South Marston Parish Council

SMPC response to S/RES/25/1389: Parcels R1 and R2 South Marston

22/11/2025

Landscaping Plan

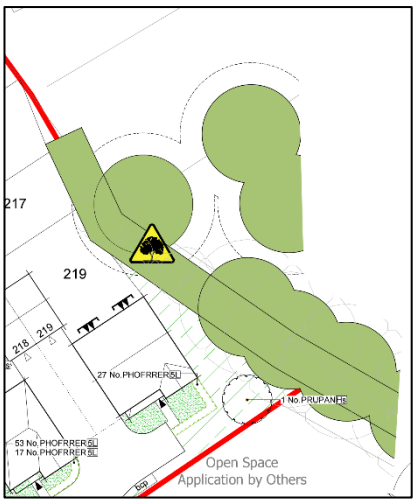
We note the plan is not showing that all three of the mature oaks on the boundary shown opposite have TPOs (plots 217-219). House 219 is currently quite close to one of these oaks and the crown will overhang its back garden.

All the landscaping shown here exists and is in third party ownership. There is apparently no additional landscaping to be provided on the boundary to strengthen separation with third-party land to the east.

To the north of this area, no existing landscaping is to be provided on the full length of the red line boundary all the way up to the planned Open Space Area adjacent to the bend in the Loop Road. We note that, instead, a 1.8m close-boarded fence is the planned boundary treatment for this stretch (Materials and Means of Enclosure Plan submitted as part of the application) and we object to that.

In other parcels in this overall development, <u>such fencing has only been allowed internal to the housing parcel site</u>. External boundaries were all required to be either landscaped, walled or with less unsightly iron railings.
